AIMOC WIM

02 - Modular static + WIM, side by side

Source: customer-supplied technical PDF, pages 3-9. Quoted prices and personal contacts are not published.

PDF specifications are distinguished from civil assumptions. Not OEM construction drawings.

PLAN · Static 18 × 3 m + WIM

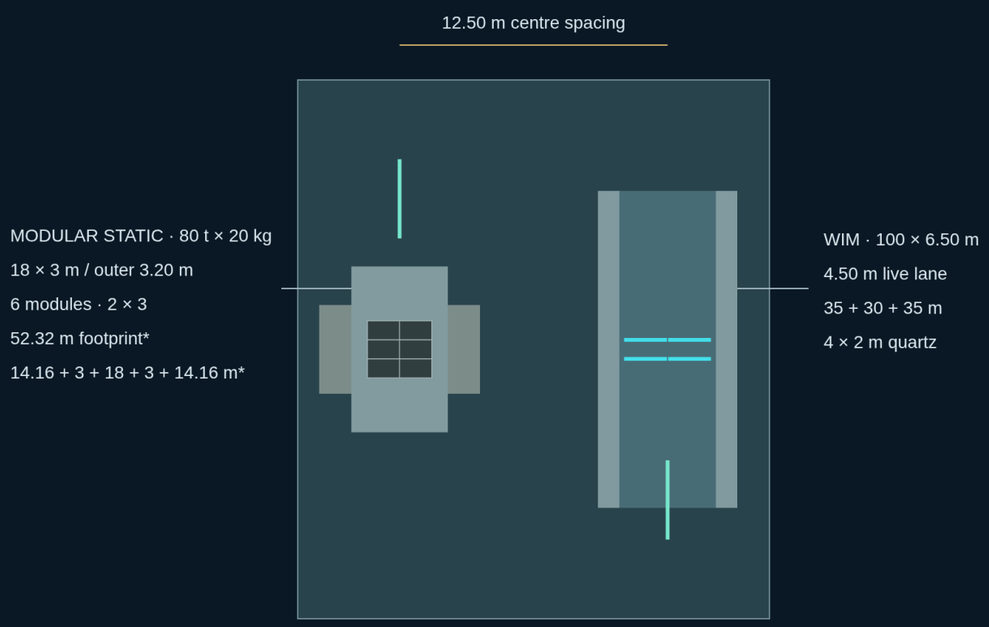
A 3.2 m truck needs tyre/guard-rail clearance review; this simulation holds that profile. QR does not replace IR.

*Ramps, landings, raft and elevations: coordination assumptions; OEM foundation unavailable.

SECTION · STEEL MODULES AND SUPPORTS

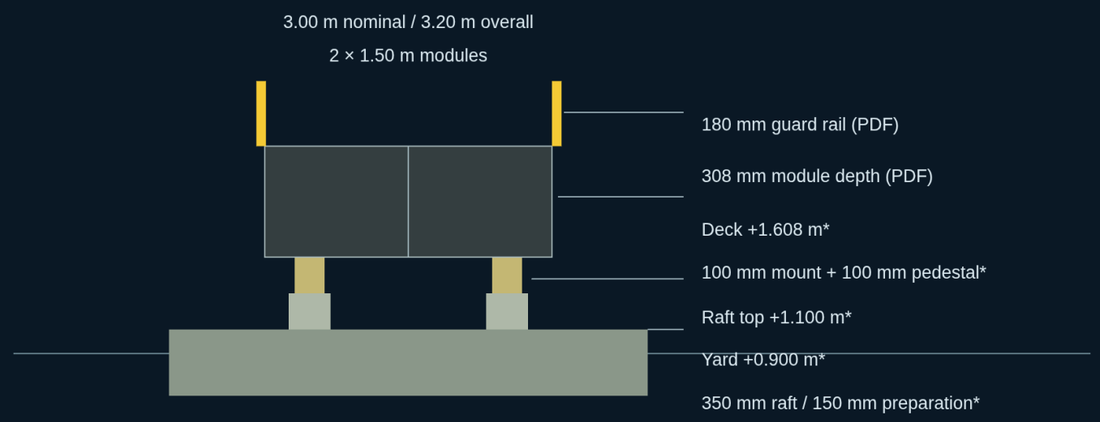
*Civil assumptions for reclaimed ground, not Static foundation details. Vertical scale exaggerated.

308 mm is total module depth, not steel plate thickness. 3D mount sizes/positions are illustrative.

Civil assumptions: 28 x 7.5 x 0.35 m raft; 100 mm pedestal; 100 mm mount; 308 mm module. OEM reinforcement, concrete grade, anchors and bearing design are not supplied. Verify settlement, flooding, drainage, corrosion and WIM interaction before construction.
